Planning Commission Meeting

Wednesday, January 22, 2025 at 6:00 PM

MEETING DATE:	January 22, 2025
PROJECT:	CVS (Store 2745) at May River Crossing - Certificate of Appropriateness-Highway Corridor Overlay District (HCO)
PROJECT MANAGER:	Charlotte Moore, AICP Principal Planner

MEETING DATE:	January 22, 2025
PROJECT:	Culver's Bluffton Preliminary Development Plan
APPLICANT:	William Heintz, Kimley-Horn
PROJECT NUMBER:	DP-10-24-019406
PROJECT MANAGER:	Dan Frazier Planning Manager Department of Growth Management

ROOF PLAN

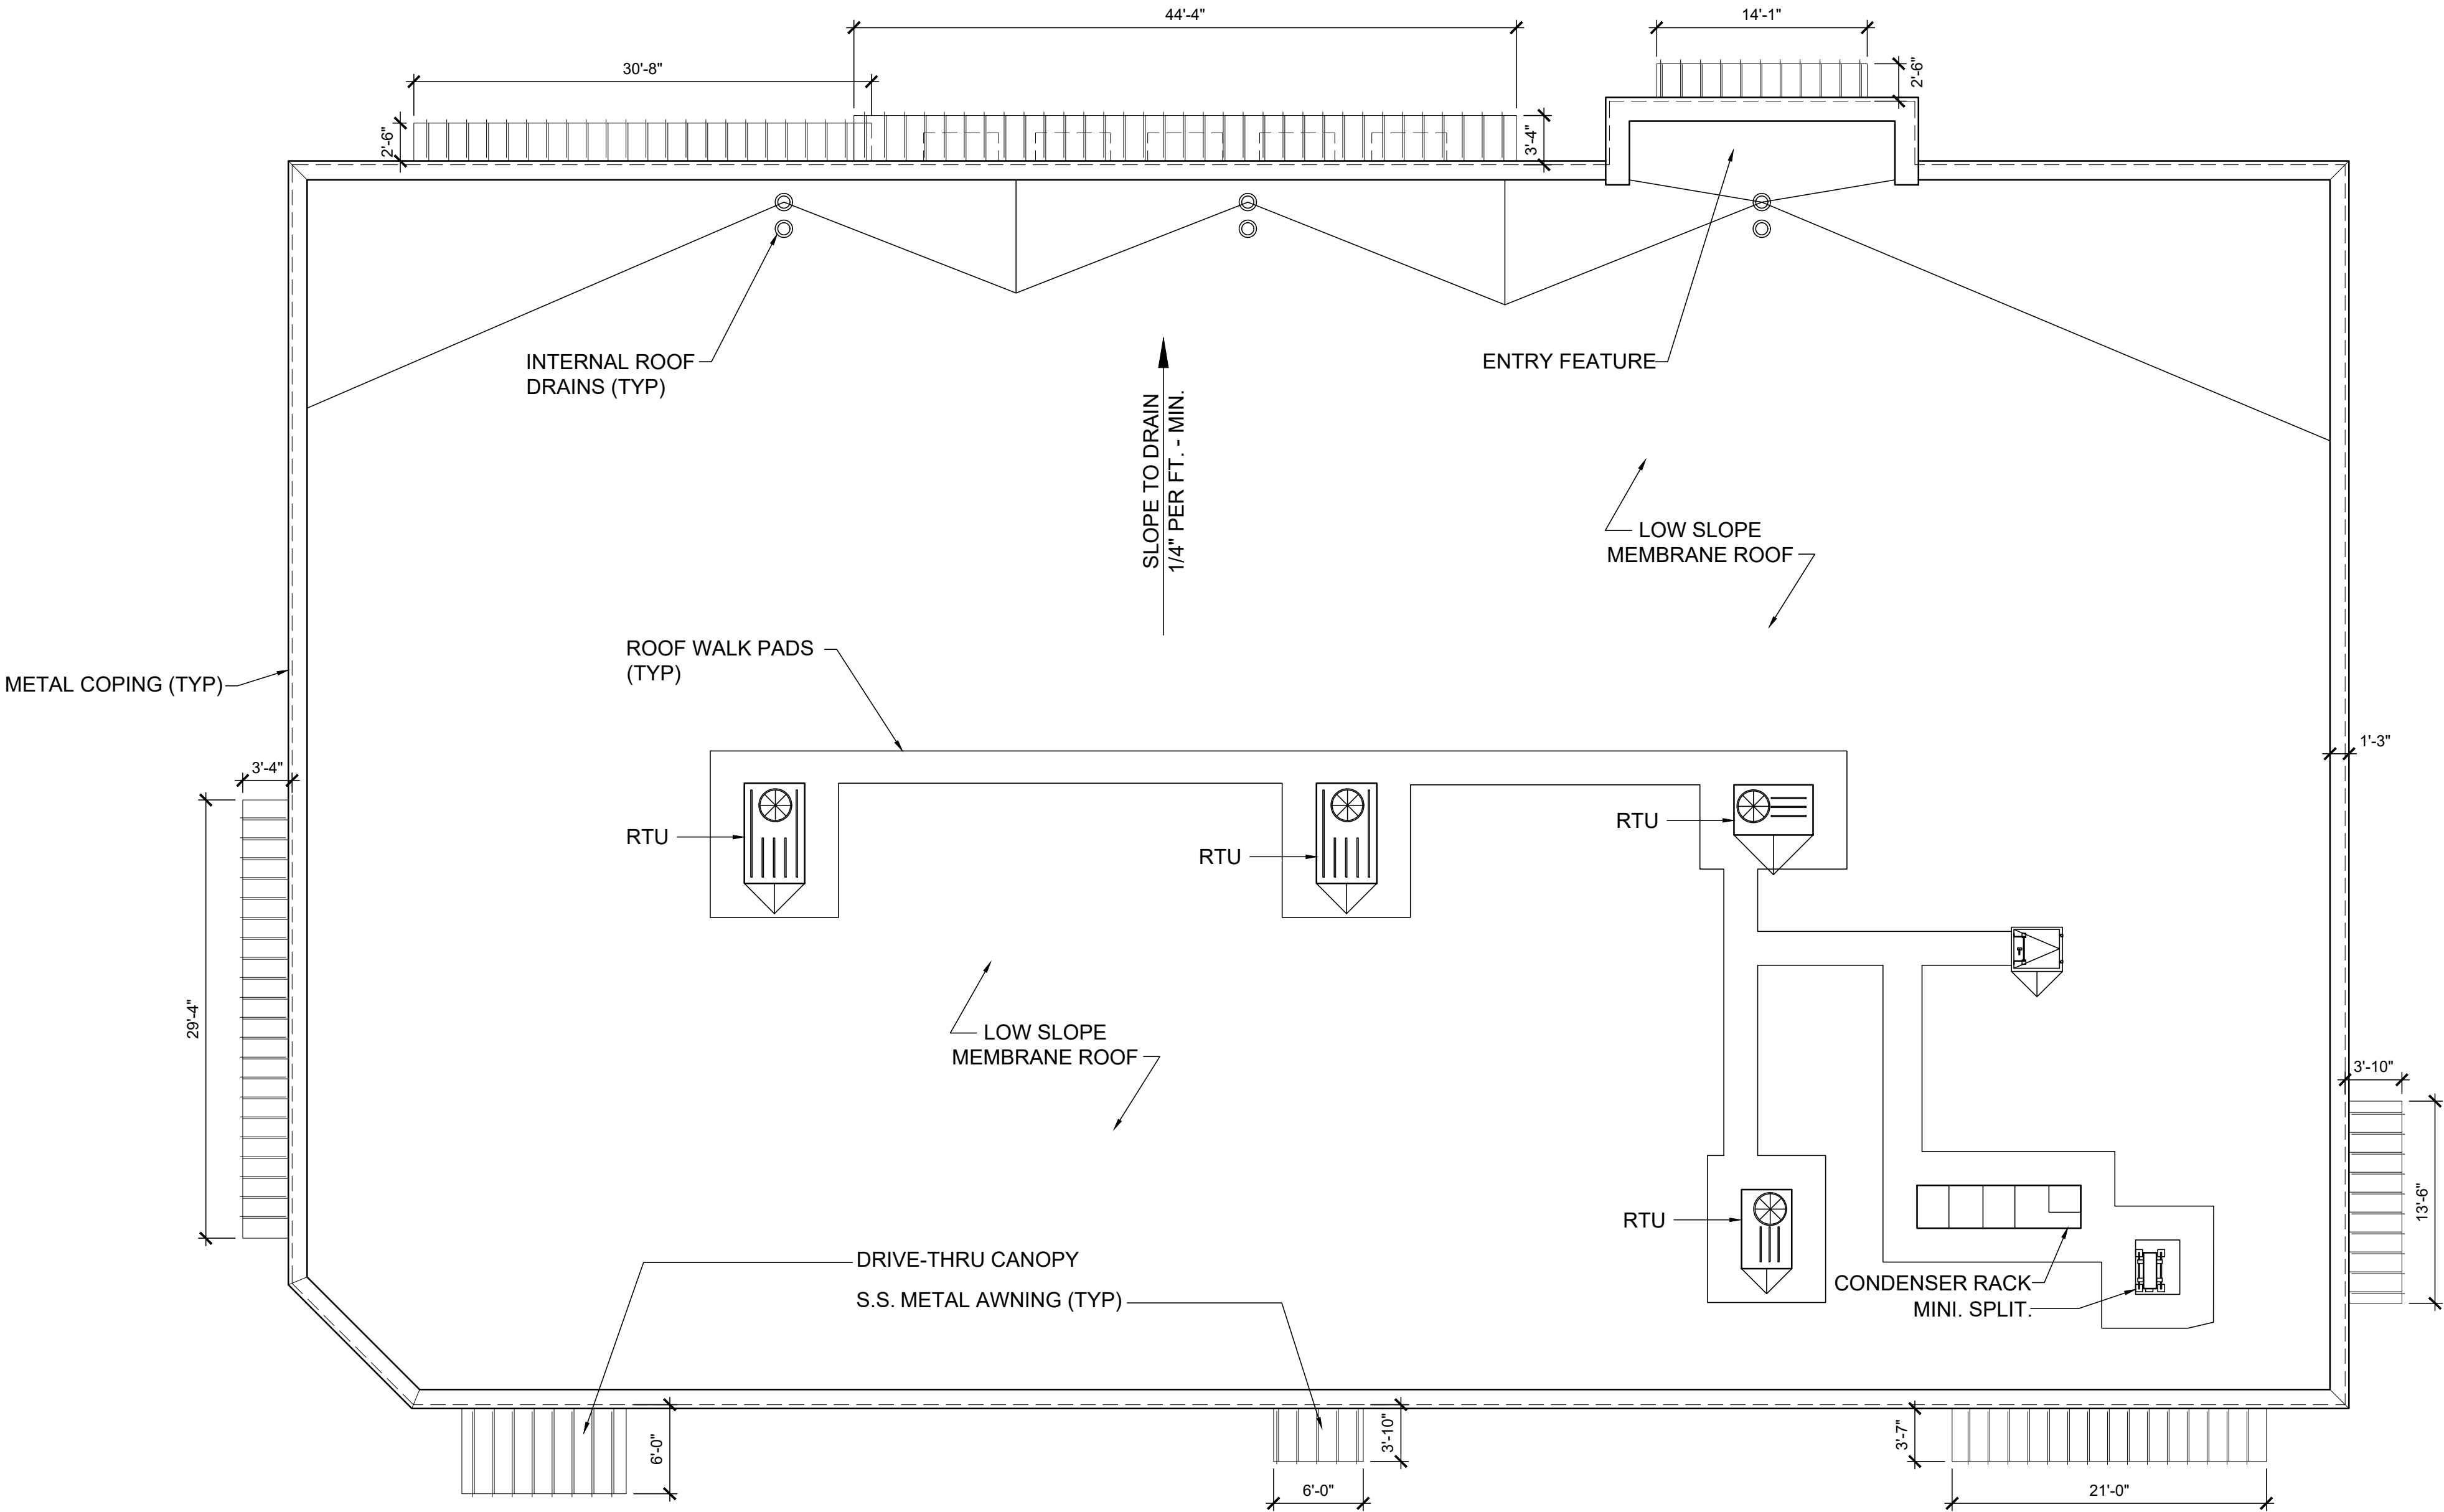
- a. **Finding – Roof.** A flat roof is proposed. Pitched roofs (4:12 pitch or greater) are more compatible and appropriate for the Lowcountry aesthetic as provided in Section 5.15.9(D)(2). Further, Sec. 5.15.9.(E)(2) identifies flat roofs without a pediment and long, unarticulated roofs as incompatible. Pitched roofs can be found on the Wendy’s and Parker’s business on Evan Way; and, flat roofs with more architectural treatment than proposed for CVS, exist on outparcel buildings located within May River Crossing. The Planning Commission must determine if the proposed roof form is appropriately representative of Lowcountry architecture and that all rooftop equipment is adequately screened. (See Attachment 5 for Roof Plan).

4. *The use of three roof types, particularly the hipped roof on the “tower” entry element, seems unnecessarily complicated and doesn’t reflect the building form. A roof plan should be provided. The entry element also seems to reflect franchise design (and showcases a corporate logo), which is atypical of Bluffton’s architecture. Provide the height of all elements that extend beyond the mansard peak. Sec. 5.15.9.(C)(4). Maximum building height is 45 feet.*

- a. Roof tower revised and hip element eliminated. Features of entry tower adapted to “low country” aesthetic.
 - b. Roof plan has been included in the resubmittal.

LANDSCAPE PLAN

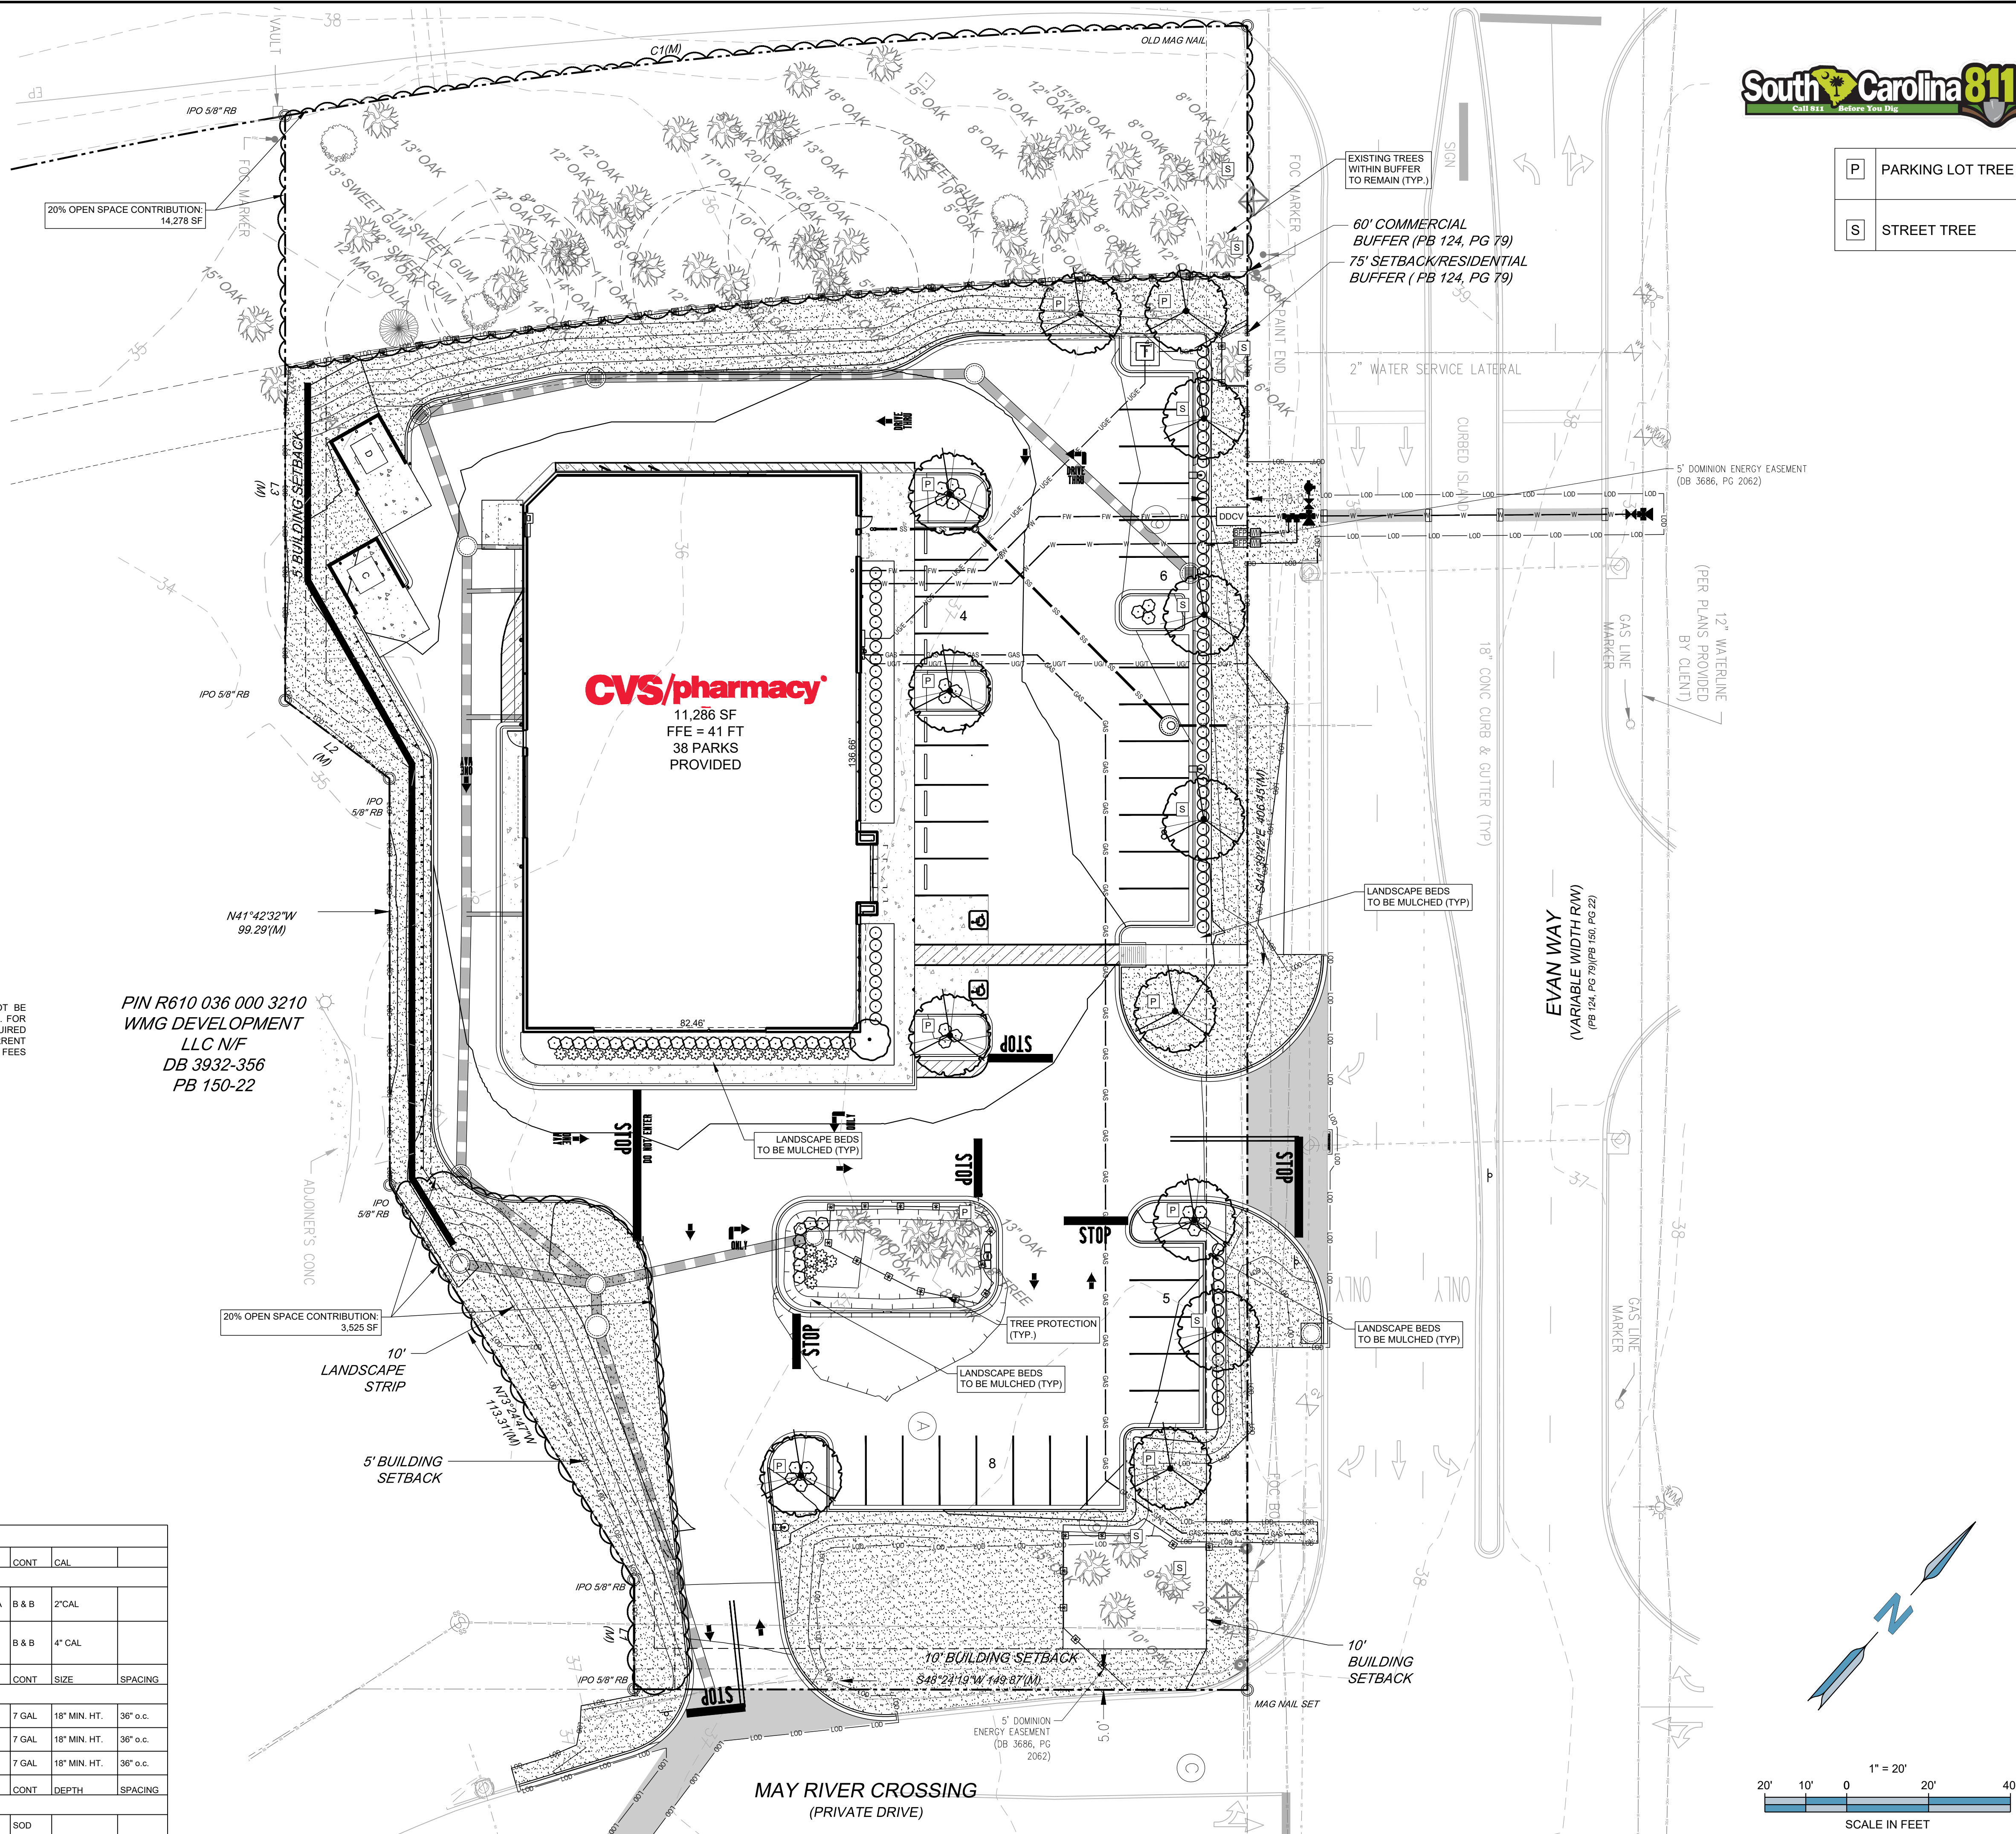
- a. **Finding – Trees.** The Landscape Plan has been revised to increase the size of the 13 Willow Oaks from 2-1/2-inch caliper to 4-inch caliper. The Landscape Plan meets the street tree, tree mitigation, and open space requirements of UDO Section 5.3. No additional tree mitigation is required.

18. As currently proposed, resizing the 13 Willow Oaks to 4" caliper at time of planting will result in only 11 trees to be mitigated. Coordinate tree mitigation requirements with Town staff prior to final COFA-HCO submittal.

19. An 8-foot landscape buffer is required between parking and driving areas but is not shown on the Hwy 170 side. Show landscape treatment on this side.

- a. Please see revised Landscape plan included within submission with Willow Oaks adjusted to 4" caliper to reduce the mitigation amount. In addition, City staff indicated they anticipate furthering the discussion on the final mitigation amount at the Planning Commission meeting.

- a. Please note we have concerns for providing 8' landscape strip against the building on the north side of the building as this would cause issues with insufficient space for bailout lane to allow vehicles a bypass around stacked cars from the drive thru. Site Plan submitted has maintained the current configuration and we would like to discuss potential alternate compliance options to meet the intent of the request at the Planning Commission meeting.
